DART AEROSPACE LTD		Work Order: 137019
Description: Crosstube Assembly (206L High Fwd)		Part Number: D206-667-143
Inspection Dwg: D206-667-143 Rev: C		Page 1 of 2

DESIGN	08	DART AEROSPACE LTD	
DRAWN	RF	HAWKESBURY, ONTARIO, CANADA	
CHECKED	08	DRAWING NO.	REV. C
MFG. APPR.	08	D206-667-143	SHEET 3 OF 4
APPROVED	08	TITLE	SCALE
DE APPR.	08	CROSSTUBE ASSY (206L HIGH FWD)	NTS
DATE	08.11.06	COPYRIGHT © 2000 BY DART AEROSPACE LTD	
THIS DOCUMENT IS PRIVATE AND CONFIDENTIAL AND IS SUPPLIED ON THE EXPRESS CONDITION THAT IT IS NOT TO BE USED FOR ANY PURPOSE OR COPIED OR COMMUNICATED TO ANY OTHER PERSON WITHOUT WRITTEN PERMISSION FROM DART AEROSPACE LTD.

DRAWING NO. D206-667-143	TITLE CROSSTUBE ASS'Y (206L HIGH FWD)	REV. C	DART AEROSPACE LTD ENGINEERING ORDER		D.E.O. NO. D206-667-143-C-1	SHEET NO. SHEET 1 OF 1	SCALE NTS
DRAWN <i>q</i>	CHECKED <i>ASS</i>	MFG. APPR. <i>JB</i>	APPROVED <i>WD</i>		DE APPR. <i>W</i>		
DATE 11.07.15	DATE 11.07.20	DATE 11.07.21	DATE 11/07/21		DATE 11.07.21

DRAWING NO. D206-667-143	TITLE CROSSTUBE ASS'Y (206L HIGH FWD)	REV. C	DART AEROSPACE LTD ENGINEERING ORDER		D.E.O. NO. D206-667-143-C-2	SHEET NO. SHEET 1 OF 1	SCALE NTS
DRAWN AJS	CHECKED J	MFG. APPR. E	APPROVED AD

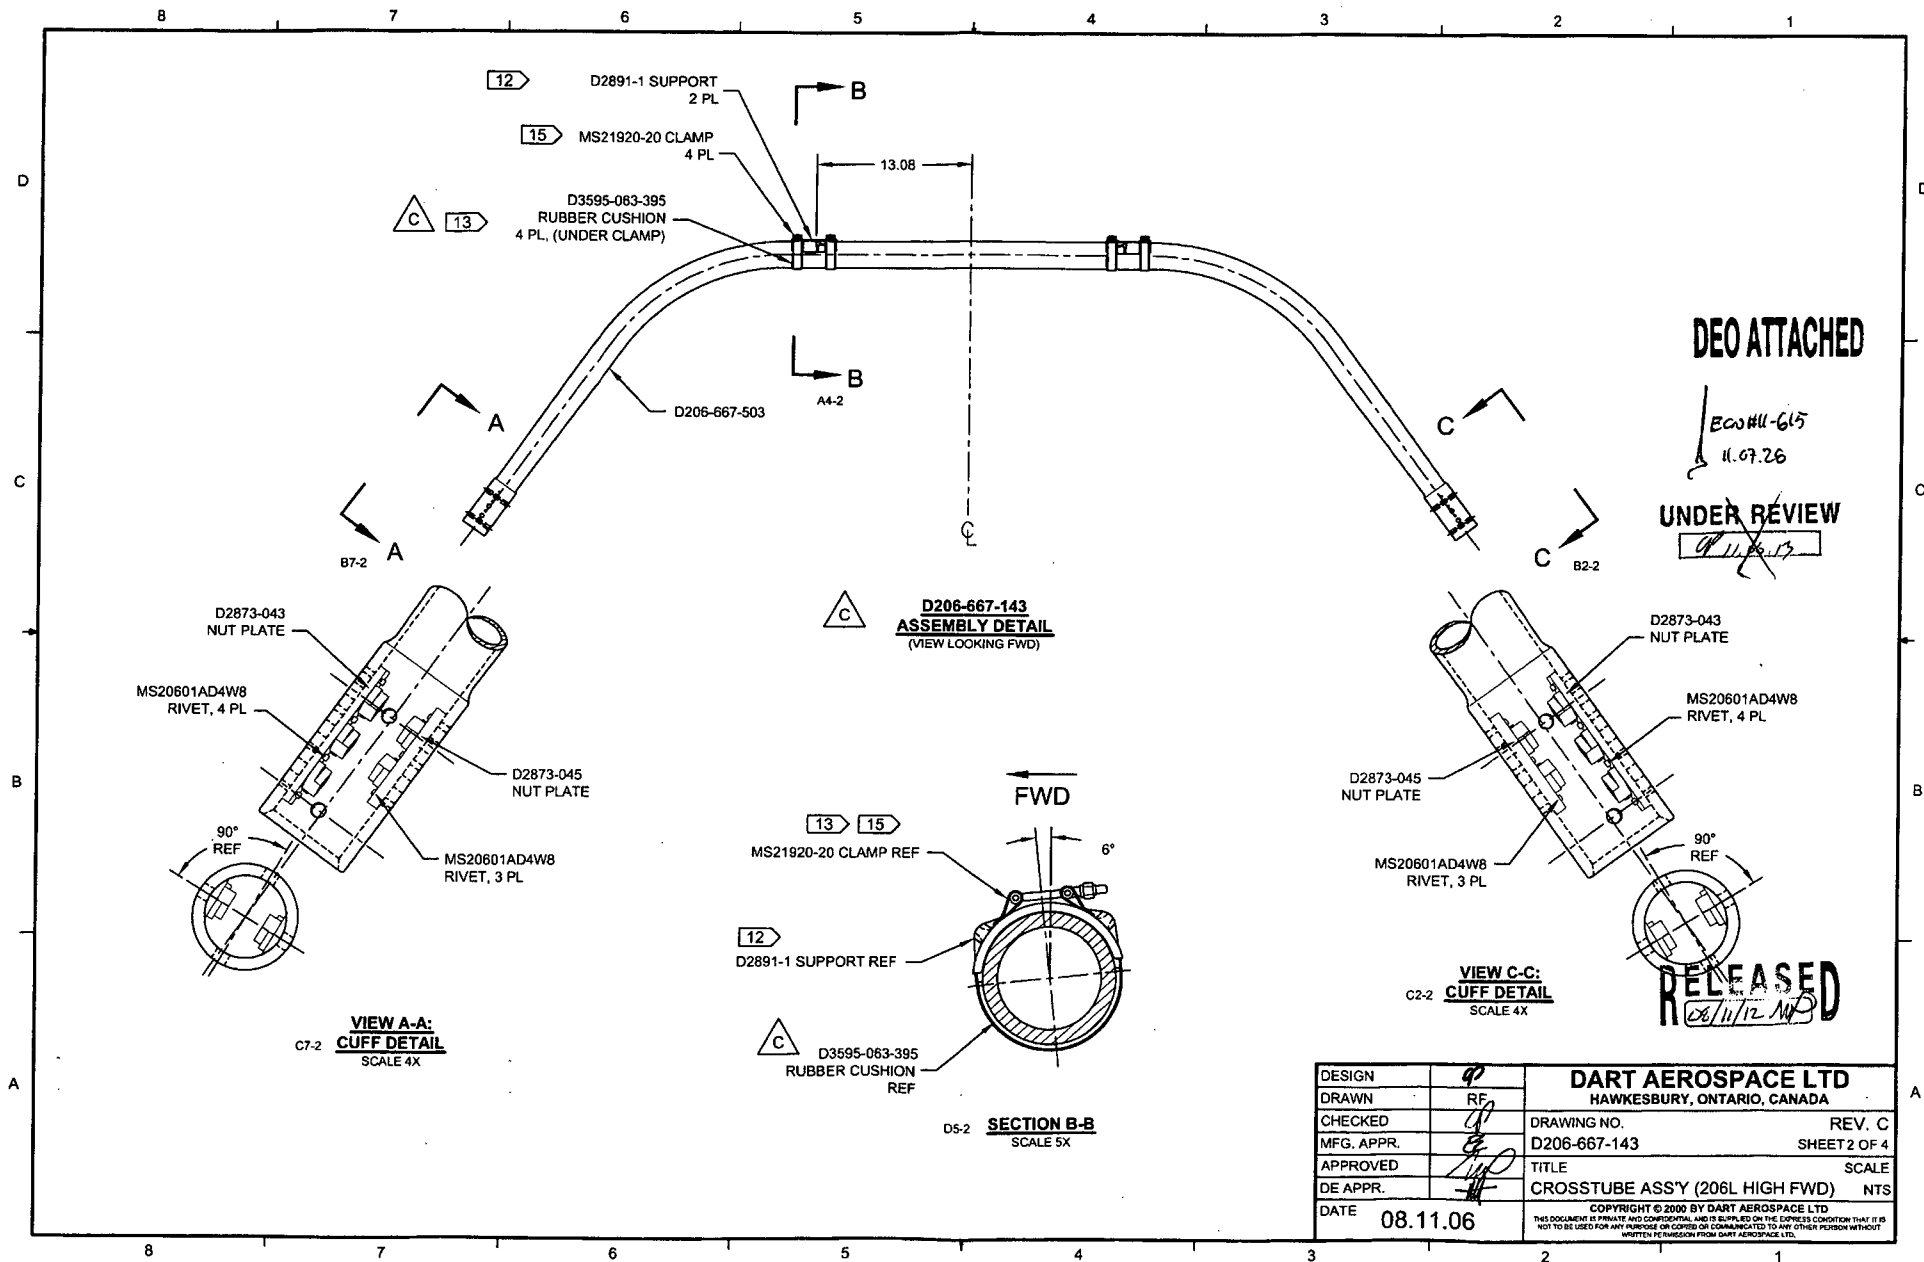
C	REVISE GENERAL NOTES/PART LIST (ZN D7-1); REORGANIZED VIEWS AND REFORMATTED DRAWING TO CURRENT STANDARDS. D3595-063-395 WAS D2856-400-694 (ZN D6-2 & A5-2); REMOVED REF. & ADD TOLERANCE (ZN D3-3, C4-3, C5-3); RELOCATED FLAG #6 (ZN A8-3) PER NCR 210; MOVED TURNING DETAIL & UPDATED TOLERANCE TO SHEET 4.	RF	08.11.06
B	ADD HOLES AND NUT PLATES FOR COMPATABILITY WITH BHT/AA SKUDTUBES	PH	05.07.26
A	NEW ISSUE	CP	00.11.17
REV.	DESCRIPTION	BY	DATE
DESIGN	RF	DART AEROSPACE LTD HAWKESBURY, ONTARIO, CANADA	
DRAWN	RF	DRAWING NO. D206-667-143	REV. C SHEET 1 OF 4
CHECKED	RF	TITLE CROSSTUBE ASSY (206L HIGH FWD)	SCALE NTS
MFG. APPR.	RF	COPYRIGHT © 2006 BY DART AEROSPACE LTD THIS DOCUMENT IS PRIVATE AND CONFIDENTIAL AND IS SUPPLIED ON THE EXPRESS CONDITION THAT IT IS NOT TO BE USED FOR ANY PURPOSE OR COPIED OR COMMUNICATED TO ANY OTHER PERSON WITHOUT WRITTEN PERMISSION FROM DART AEROSPACE LTD.	
APPROVED	RF	DATE 08.11.06

DETAIL P
BONDING STRAP INSTALLATION 2 PL

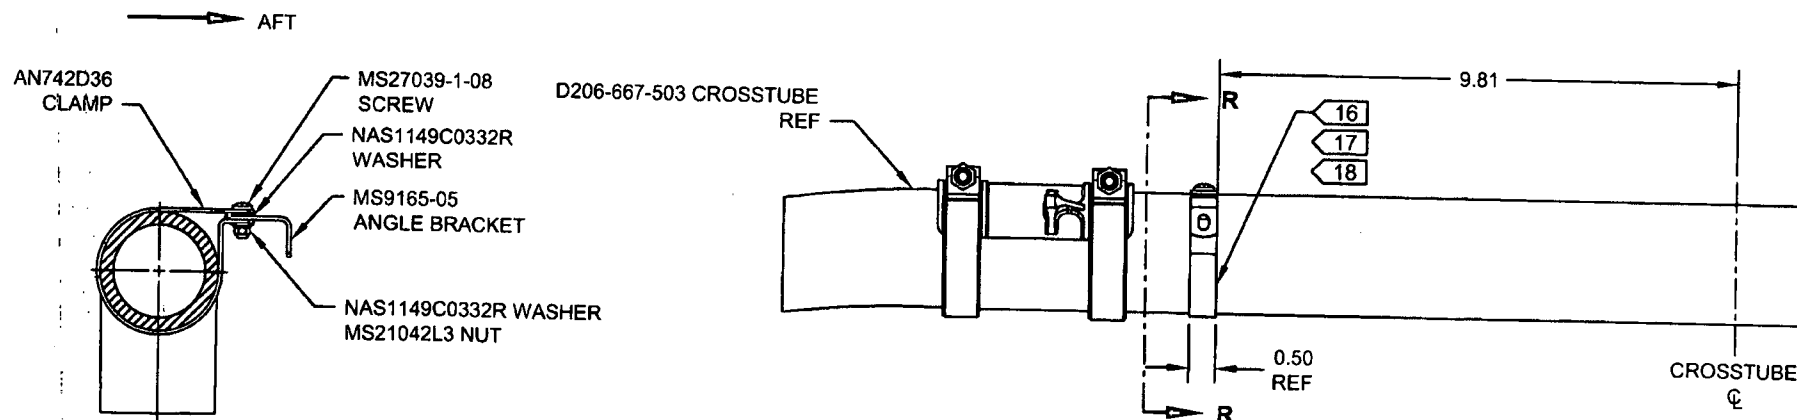
ADD ELECTRICAL GROUNDING STRAP

ITEM	QTY	PART NUMBER	DESCRIPTION
1	X	D206-667-143	CROSSTUBE ASSEMBLY (206L HIGH FWD)
10	2	AN742D36	CLAMP
11	2	MS9165-05	ANGLE BRACKET
12	2	MS21042L3	NUT (OR MS21042-3)
13	2	MS27039-1-08	SCREW
14	4	NAS1149C0332R	WASHER (OR AN960C10L)

- 16) MASK AREA UNDER CLAMP PRIOR TO PAINTING
- 17) SEAL EDGES WHERE AN742D36 CLAMP MEETS WITH THE CROSSTUBE USING SIKAFLEX-241/-291 OR MIL-S-8802 CLASS B2 OR PROSEAL 890 SEALANT
- 18) PERFORM RESISTANCE CHECK TO ENSURE MAX RESISTANCE IS 10 MILLIOHMS
